STAFF REPORT AND RECOMMENDATION ON APPEAL
SUBSTANTIAL ISSUE

APPEAL NO.: A-6-CII-01-20

PROJECT DESCRIPTION: Demolition of an existing 3,344 -sq. ft. three unit residential structure and construction of a two-story, 28-foot high, 3,572 sq.ft. single family dwelling and attached 416 sq.ft garage on an 8,712 sq.ft. blufftop site. Also proposed is removal of an existing wooden bluff stairway and installation of a new concrete stairway, planter, drainage structure and decks on the bluff face.

PROJECT LOCATION: 3075 Ocean Street, Carlsbad (San Diego County) APN 155-104-04

EXHIBIT NO. 2
APPLICATION NO. A-6-CII-01-20
Site Plan
California Coastal Commission

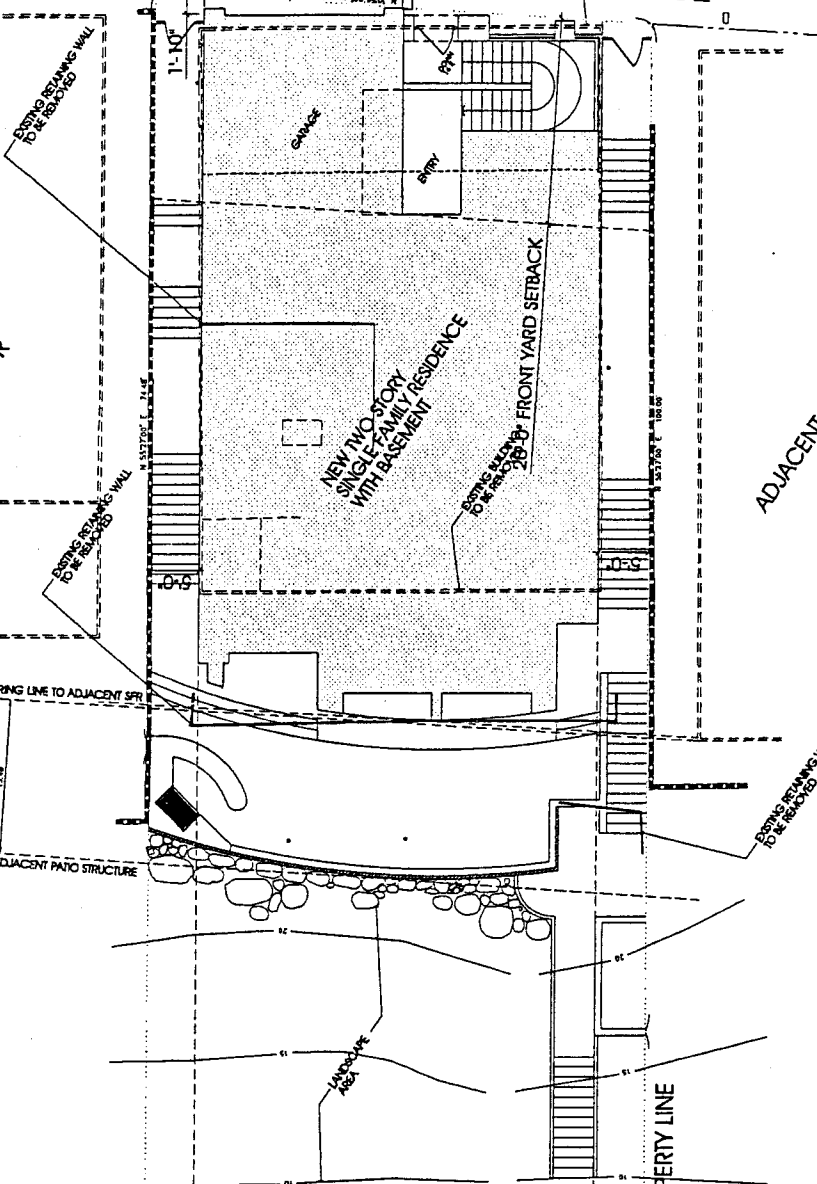
The proposed project is new development on the seaward side of Ocean Street. The City found that the project is consistent with the above stringline provisions of the LCP. However, the City applied the stringline incorrectly. The Commission has interpreted the above cited stringline provision of the LCP to require that the "stringline" be measured from the nearest point of adjacent structures immediately to the north and south of the proposed development (ref. CDP Nos. 6-90-25/Kunkel; 6-90-299/Rowe; 6-92-107/Phillips and 6-95-144/Bownes). In this instance, however, the City measured the stringline line from the middle portion of the adjacent structure to the north that juts further seaward than the rest of the structure. Consequently, as approved by the City, the above grade portion of the proposed structure is sited approximately 7 feet further seaward than if measured from the closest corner of the building, inconsistent with the

Additionally, the proposed project is also inconsistent with the stringline for accessory structures. The proposed development includes a large concrete planter (12' x 5'), "cosmetic" boulders, private stairs and a drainage structure, all seaward of the proposed residence on the bluff face. The concrete stairs and drainage structure extend to beach level at approximate elevation 10 MSL. The proposed planter extends to elevation 16 MSL, about mid way on the bluff. However, planters and other similar structures on the adjacent sites are located at least 11-feet upland of the subject planter, no lower than elevation 21 MSL. Finally, the proposal includes the installation of large boulders on the bluff face seaward of the mechanical equipment room at approximate elevation 20 MSL. According to the applicant, the boulders are "cosmetic" (are decorative and would not affect bluff stability); however, the Commission finds they must be considered accessory structures for purposes of determining the accessory stringline. As such, the boulders extend approximately 5-feet seaward of the accessory stringline identified by the City. Thus, the Commission finds the proposed development raises a substantial issue with the stringline provisions of the LCP with regards to both the main residence and accessory stringlines.

EXHIBIT NO. 8
APPLICATION NO. A-6-CII-01-20
Mechanical Equipment Room
California Coastal Commission

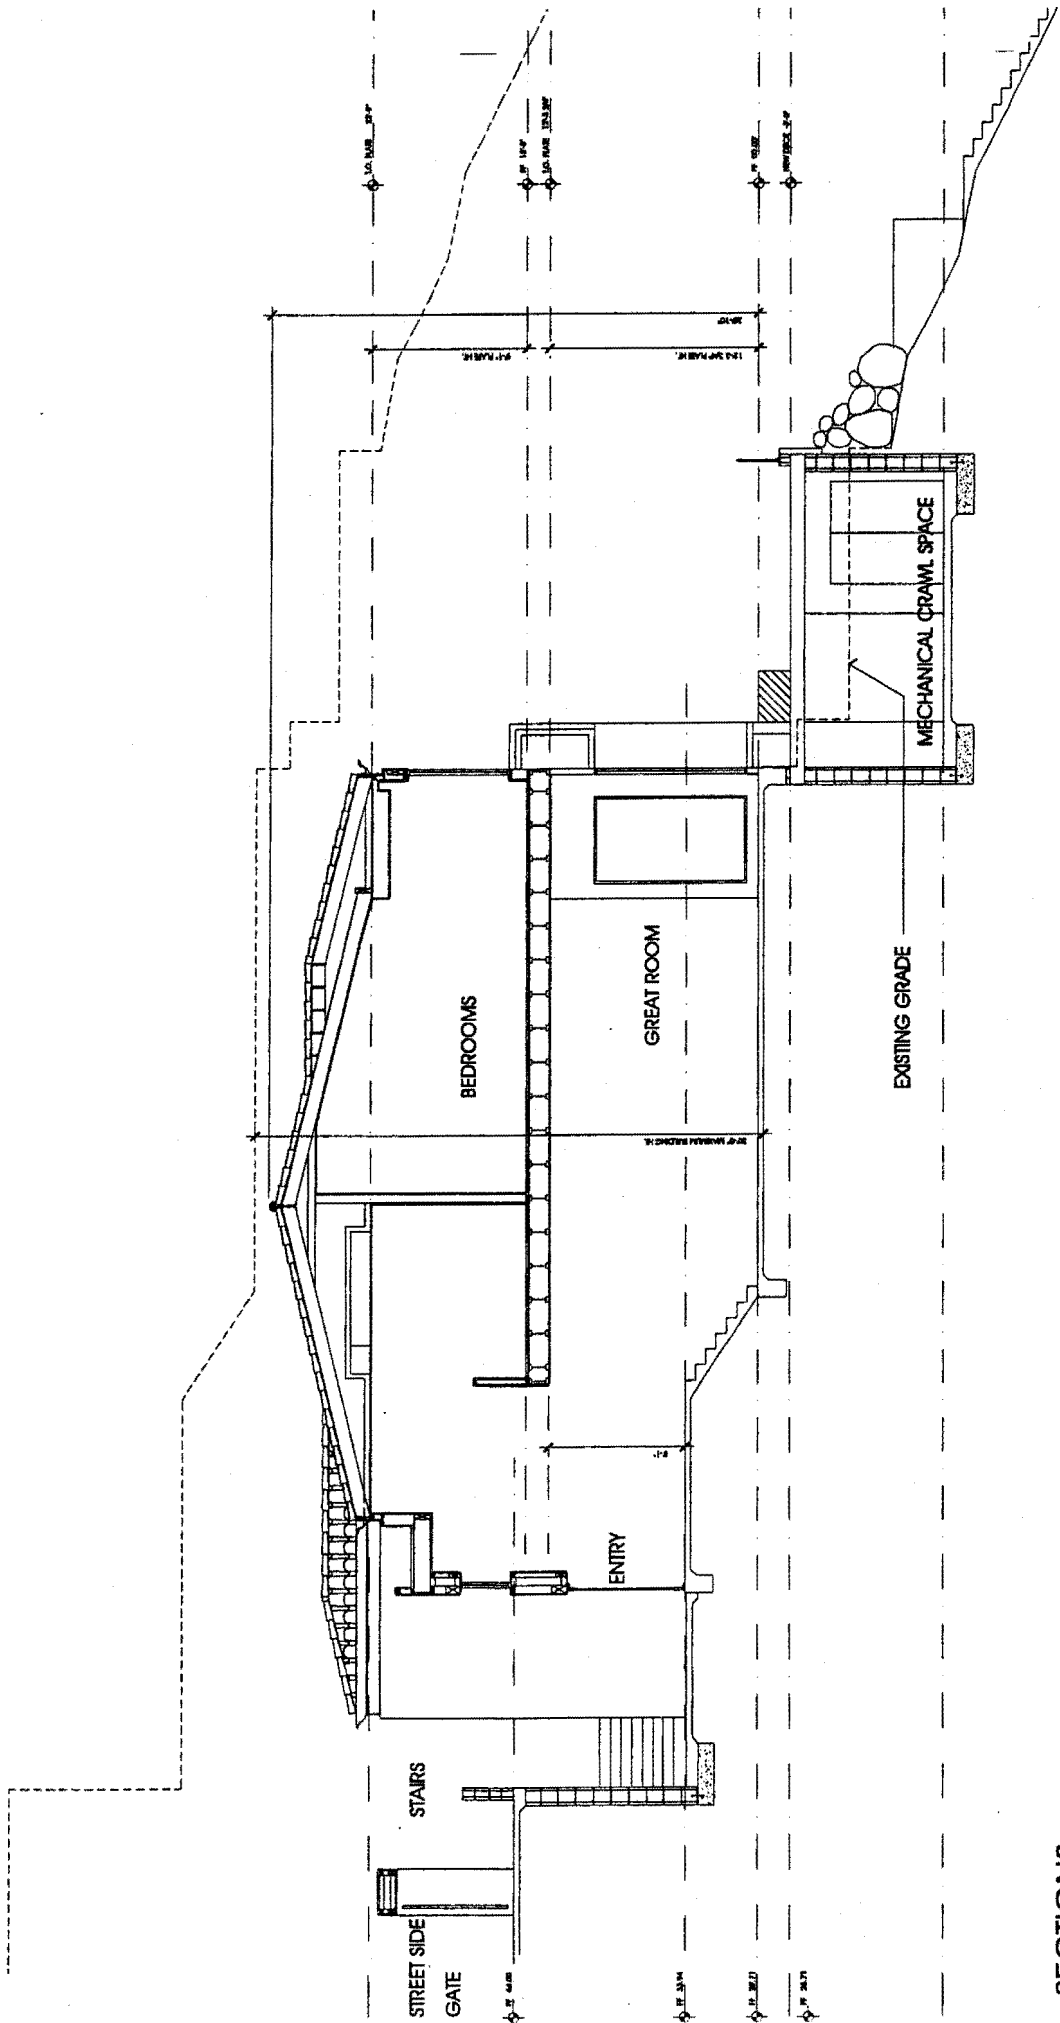
Additionally, the new residential structure also includes a mechanical equipment room which is proposed beneath the proposed elevated concrete deck on the western side of the proposed residence. Grading into the bluff face is required to locate the mechanical equipment room; the room would be approximately 8-feet high and will extend approximately 3-feet above grade. It appears the mechanical equipment room, which is attached to the main residential structure, represents the most seaward portion of the proposed residence and as such, should comply with the stringline associated with the principle structure. As the seawardmost portion of the home, the proposed mechanical equipment room will extend approximately 18-feet seaward of the "principal structure" stringline as determined by staff.
